## IDAP REPORT

<b>Property:</b>	122 Barker Road STRATHFIELD Lot 6 DP 16130 DA 2021/144
<b>Proposal:</b>	Demolition of existing structures, tree removal and construction of a two (2) storey dwelling house with basement level and in-ground swimming pool.
<b>Applicant:</b>	Douglas Design
<b>Owner:</b>	F Reza & R I Fakir
<b>Date of lodgement:</b>	28 June 2021
<b>Notification period:</b>	6 July 2021 to 20 July 2021
<b>Submissions received:</b>	One
<b>Assessment officer:</b>	J W Brown
<b>Estimated cost of works:</b>	\$1,910,000.00
<b>Zoning:</b>	R2-Low Density Residential - SLEP 2012
<b>RECOMMENDATION OF OFFICER:</b>	APPROVAL

Figure 6: Snippet of proposed dwelling section.

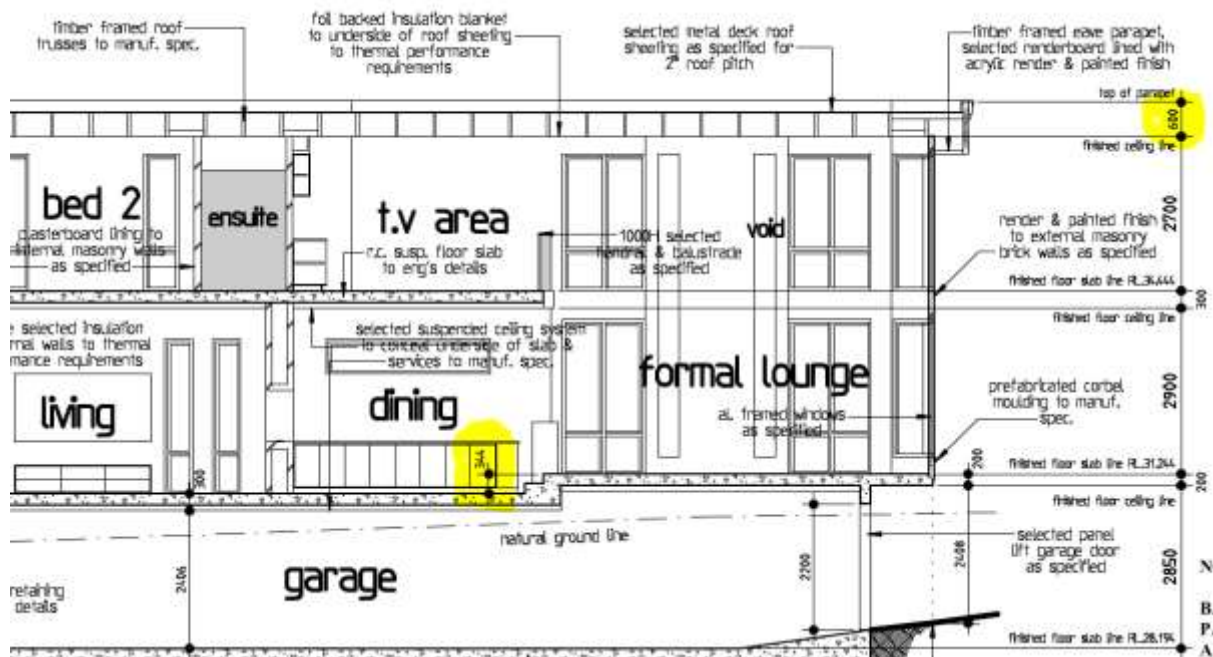
A section of the ground floor is above the maximum 3m floor to ceiling height required under the SCDCP 2005. This is due to that, the property slopes to the rear and the dwelling steps down to follow the contours of the site. The extra 244mm is acceptable in these circumstances as it creates a larger space for the main living areas of the proposed dwelling. Overall, the non-compliance is acceptable

The overall height of the dwelling is not compliant with the SCDCP 2005 as it protrudes an extra 100mm above the 7.8m requirement. A reduction of the parapet height to 500mm will make the design compliant with the SCDCP 2005 and will make a small reduction to the overshadowing of neighbouring properties.

Parapet Height	The parapet height must be lowered 100mm.
Bedroom 3 Ensuite Window	The window is required to have an obscured finish (i.e frosted)
Laudry Glass Door	The glass door is required to have an obscured finish (i.e frosted)
Basement storage and store room	Must be non-habitable rooms with a maximum floor to ceiling height of 2.1m

Figure 6: (Left) Original second storey setback, (Right) Updated second storey setback

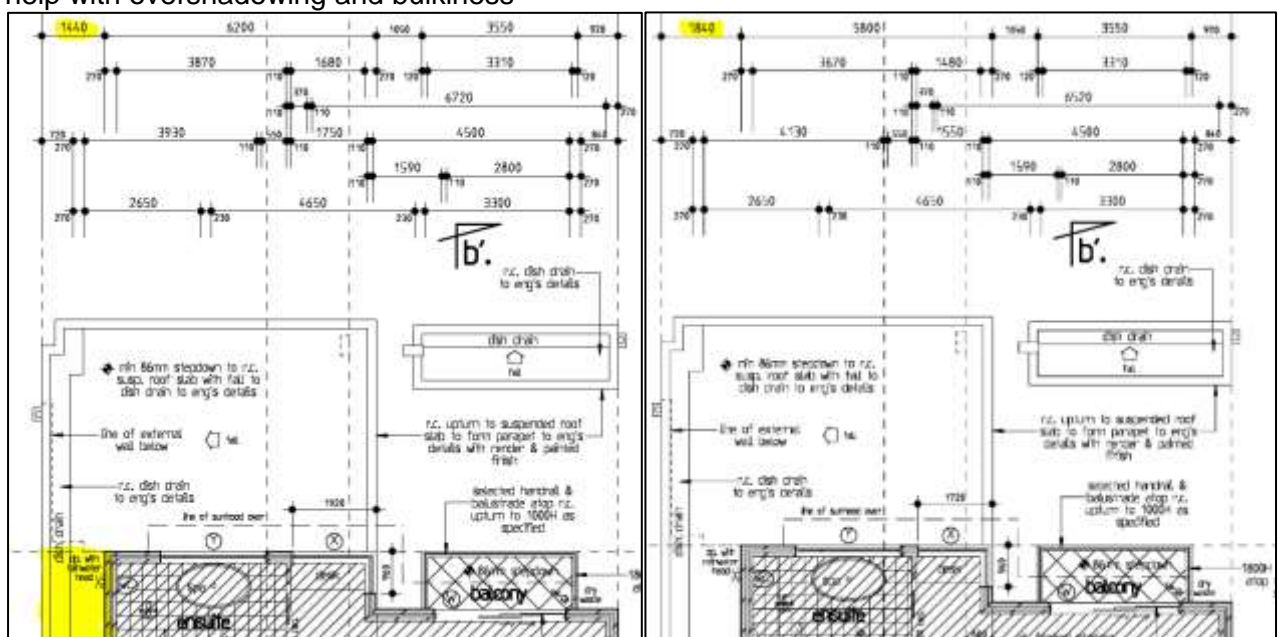
**Comment:** The eastern neighbouring property was concerned about the overall bulkiness of the development and how it produces significant overshadowing on their property. The development is aligned with both dwellings at the front setback and has compliant side setbacks on the east and west boundary. The main issue is the rear part of the proposed dwelling as it extends into the rear yard further than the existing eastern neighbouring dwelling. The applicant on request provided a further 400mm setback, of the second storey at the rear to improve the bulkiness and overshadowing onto the eastern neighbour. This created an overall side setback of 3.6m for the second storey part of the proposed dwelling, that is beyond the neighbouring properties rear building line.

This change will help to reduce the overshadowing and the bulkiness in the rear of the proposed dwelling. The side setback and height are compliant with SCDCP 2005 will also help with overshadowing and bulkiness

Further, the overall height will be reduced as the parapet height has been conditioned to be reduced by 100mm to be compliant with the SCDCP 2005. This will also help reduce the overall bulkiness of the development as well as improving overshadowing. The eastern neighbour already receives adequate sunlight from 9am to 12pm, which is considered sufficient under the SCDCP 2005, understandably the neighbouring property to the east, is affected in the afternoon due to the orientation of the site. The above reduction in height will help to improve the overall overshadowing, not just for neighbouring property to the east, but for all neighbours impacted.
